Wollongong Local Planning Panel Assessment Report | 6 November 2019

WLPP No.	Item 1
DA No.	DA-2019/96
Proposal	Novotel Northbeach - addition of suite to existing rooftop level
Property	2-14 Cliff Road, North Wollongong
Applicant	Michael Anagnostou
Responsible Team	Development Assessment and Certification – City Centre Team (RW)

ASSESSMENT REPORT AND RECOMMENDATION

Figure 3: Site plan showing surrounding heritage items and heritage conservation areas (red hatched area is the North Beach precinct)

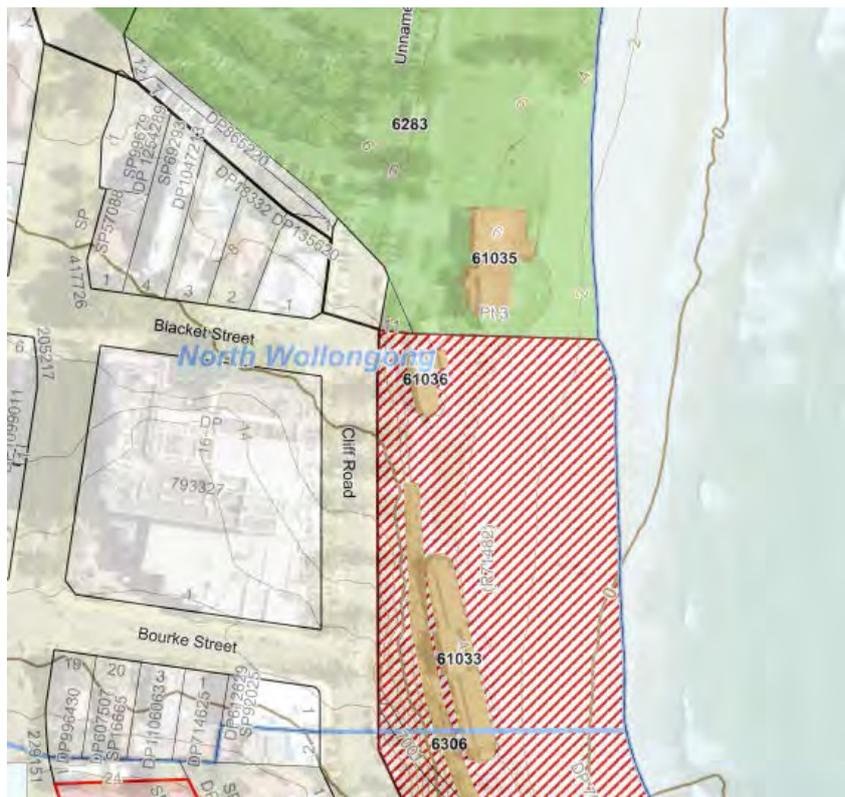
The provisions of Clause 5.10 have been considered by Council's heritage division and found unsatisfactory due to the visual impact of the development which arises from the non-compliant building height. The objectives of this clause are not satisfied as the proposed addition will lead to cumulative impacts on the settings and views of the adjacent state heritage listed North Beach Precinct. This is discussed in more detail in part 1.4 of this report.
